**NOTICE OF MEETING**

An Ordinary Meeting of the Town Planning Committee will be held on Tuesday, 2 June 2020 at East Fremantle Town Hall, 135 Canning Highway, East Fremantle commencing at 6.30 pm and your attendance is requested.

The purpose of this report is for Council to consider a planning application for a proposed loft addition at No 10 (Lot 24) Bolton Street, East Fremantle.

Perspective from Eastern Neighbours Balcony

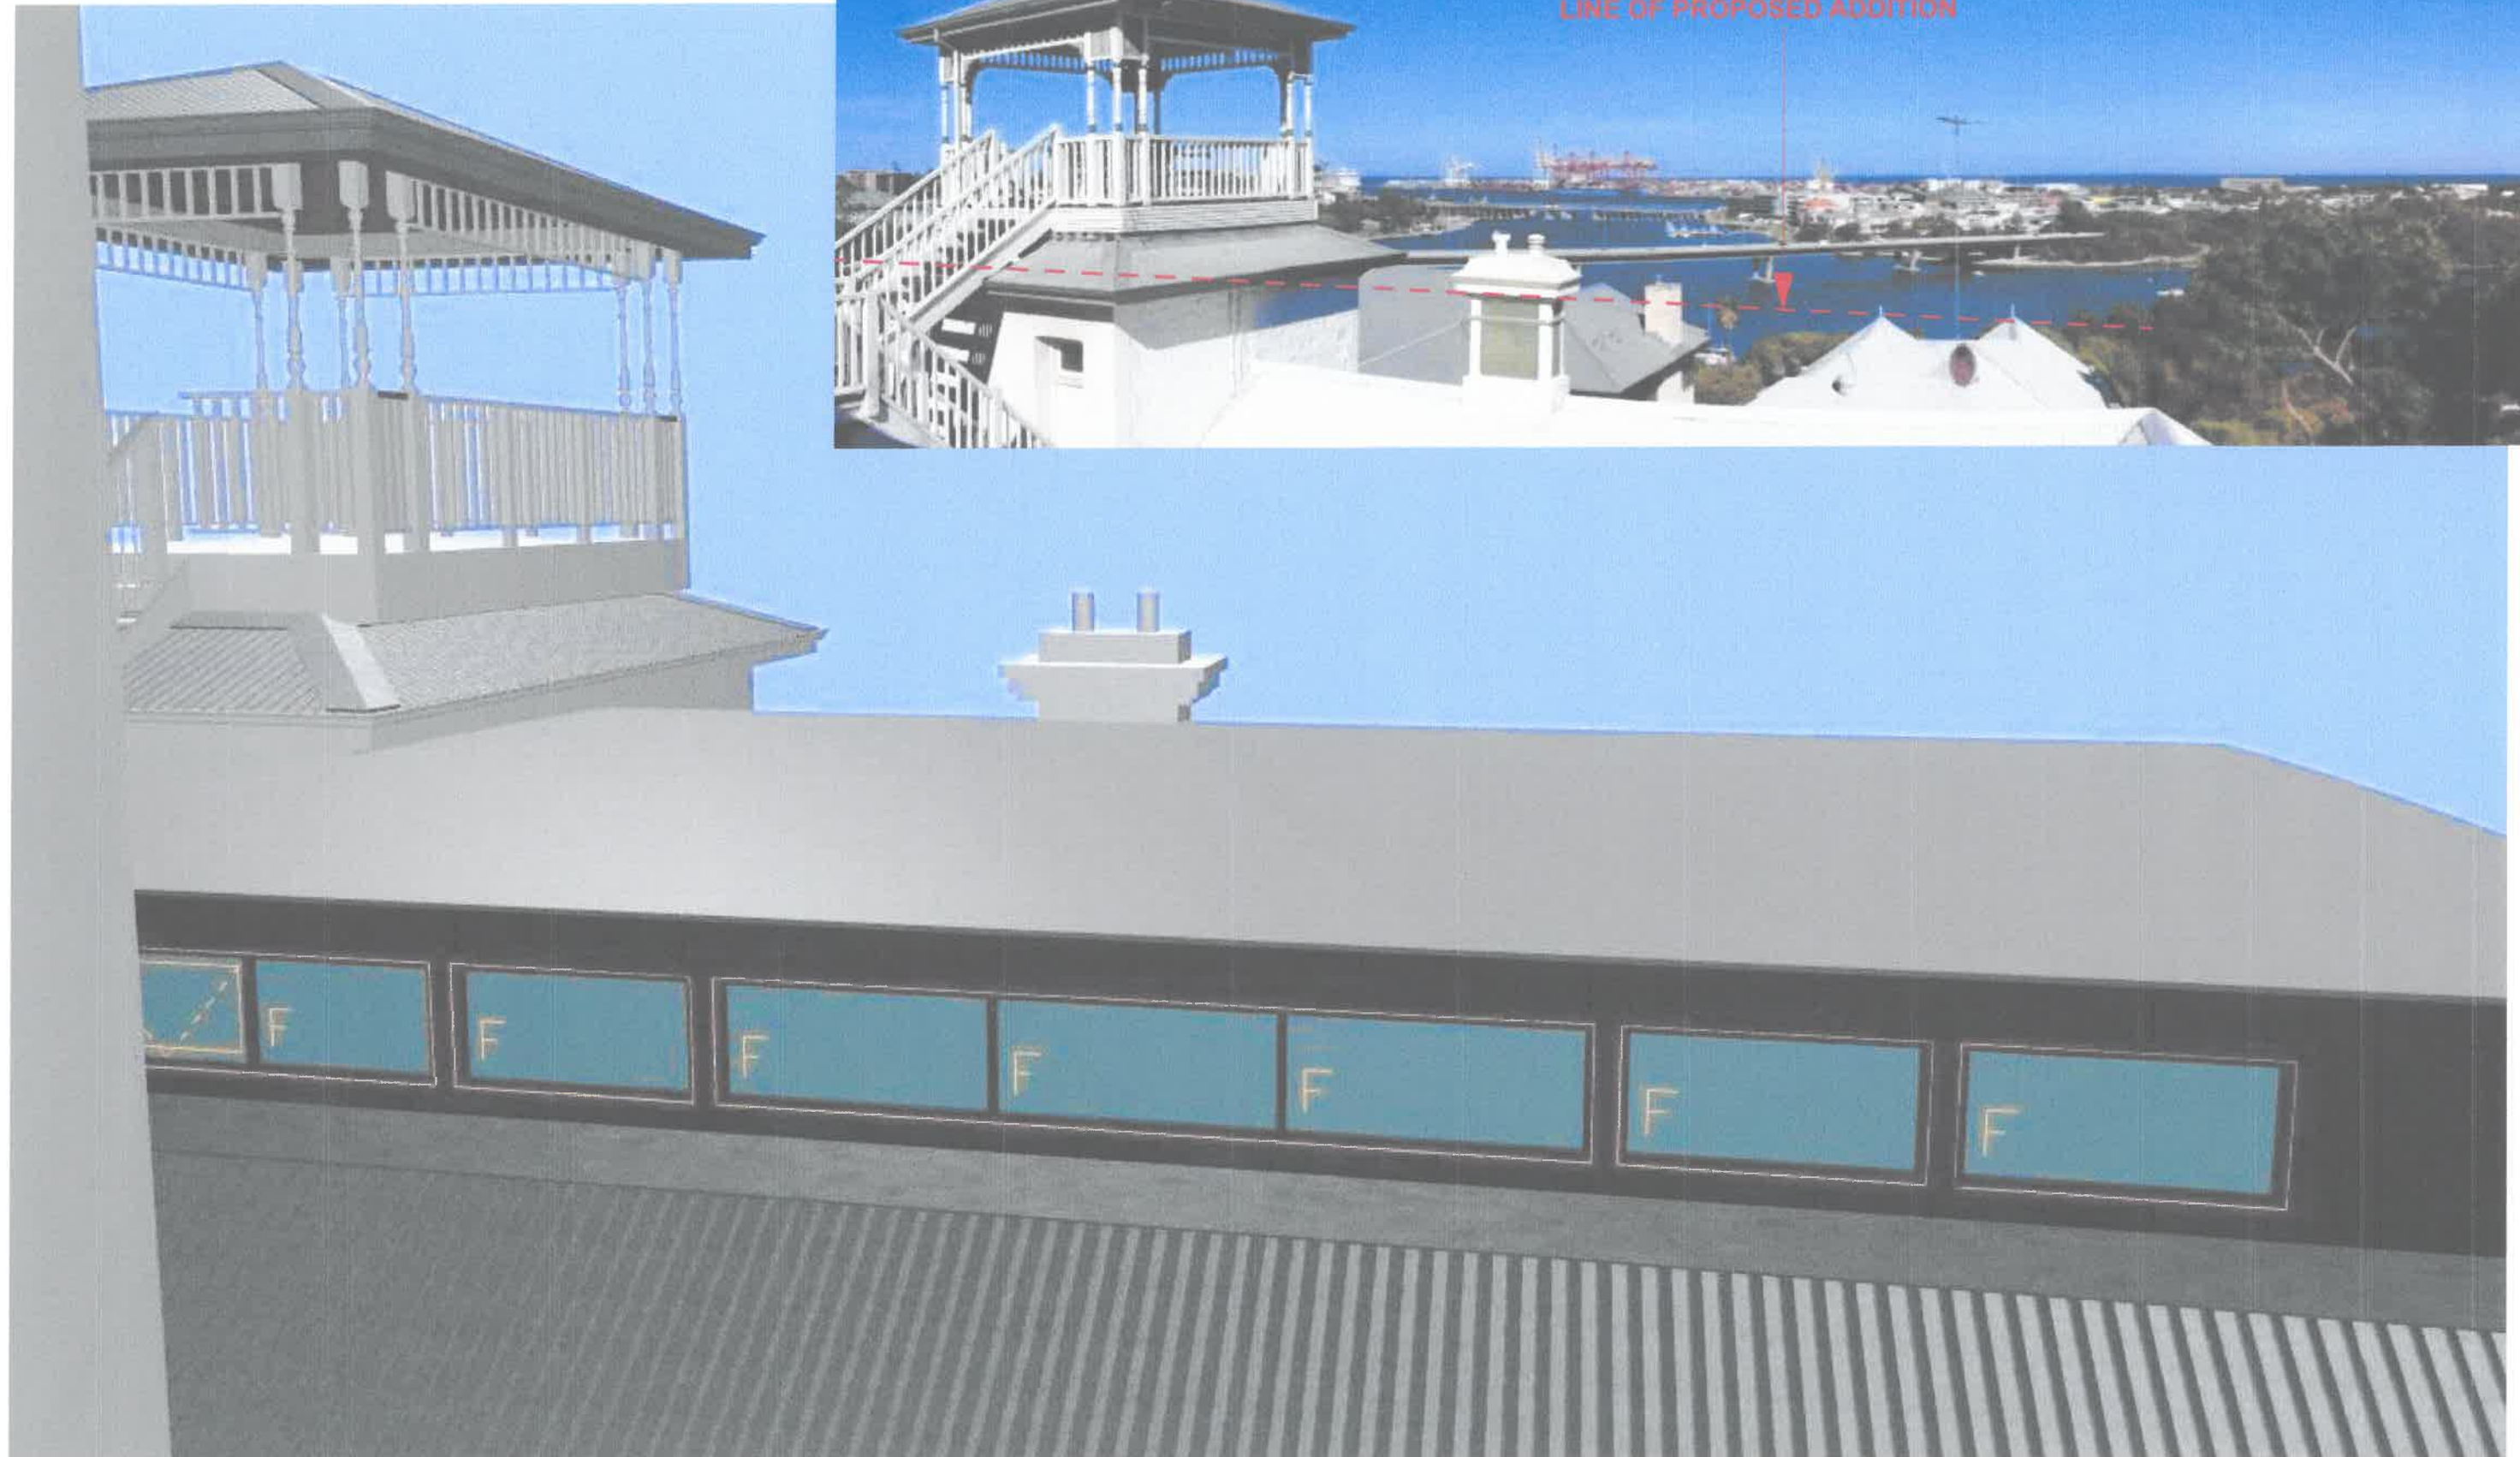
- The design is 'within' maximum 8.1m height levels
- Is 'under' the line of sight from the Eastern neighbours upper floor Balcony and
- 'Nominally' impacts the water vista of the neighbours to the East (refer sections and photographs included in the drawing set)

Comparison of previous and current proposal

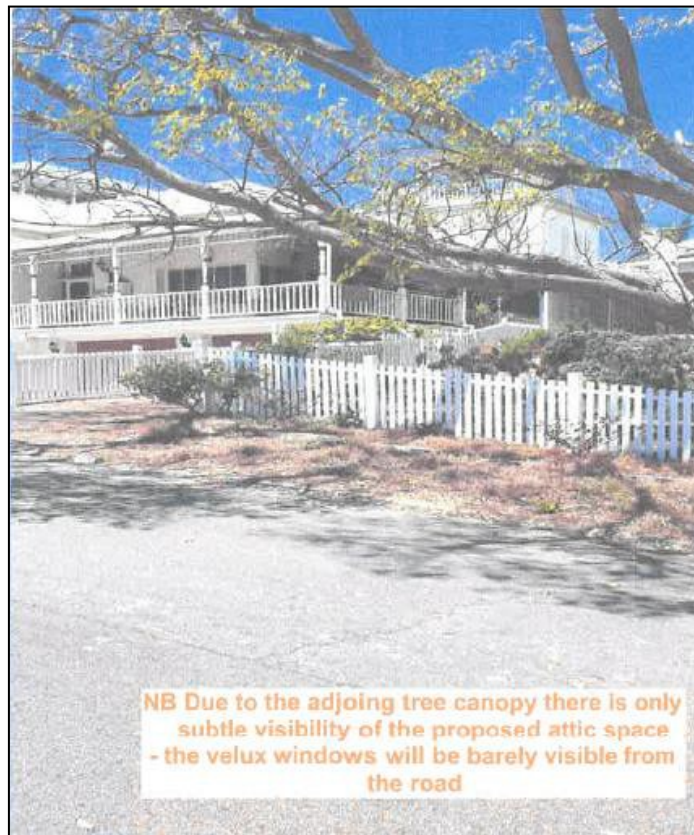
Importantly and with regard to points “a” and “b” above the revised design has actually brought the visible loft space forward via its box design and now has more prominence than the previous design as is demonstrated in the figures below.

Loft extension clearly visible from the street front, contrary to design guidelines.

Figure 4. Note Chimney substantially less prominent

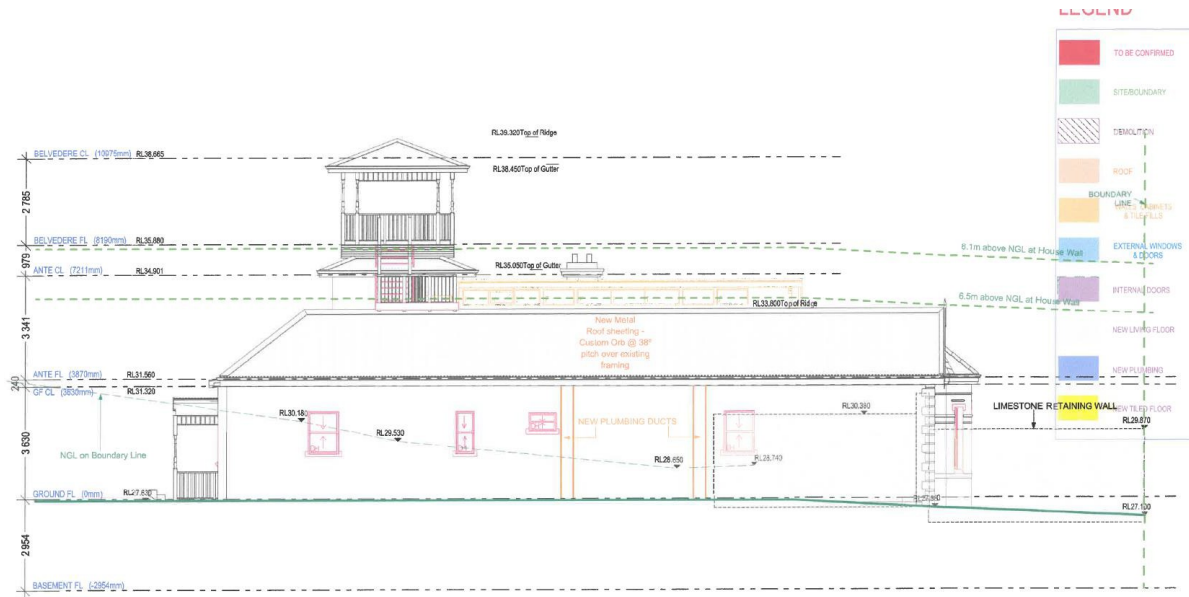
The use of the correct line of view, would clearly illustrate that the clerestory windows are visible, a significant portion of the belvedere is obscured and changes the to the roof line are very apparent.

Figure 5. Photo of original property where prominence of belvedere and chimneys are clear.

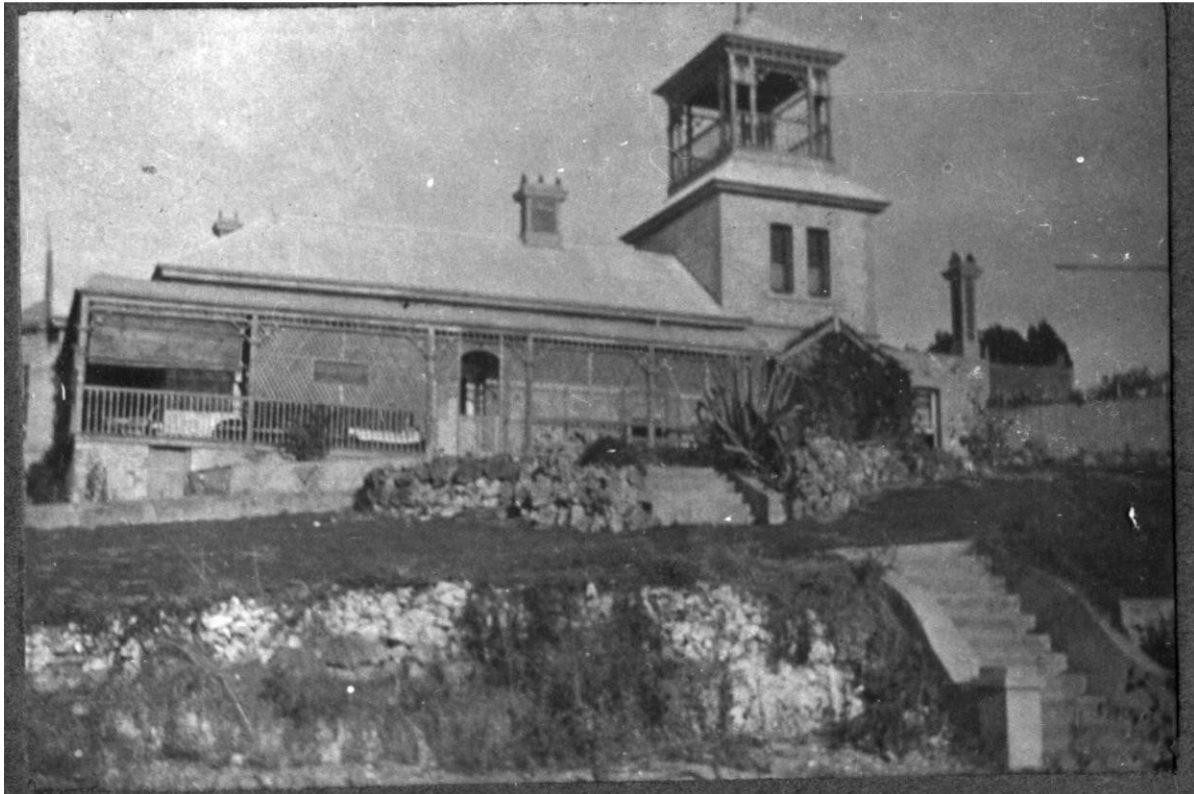
- *The revised proposed roof design also enables the belvedere and chimney to remain as is from the west, whilst being only 'nominally' obscured in part from the east.*
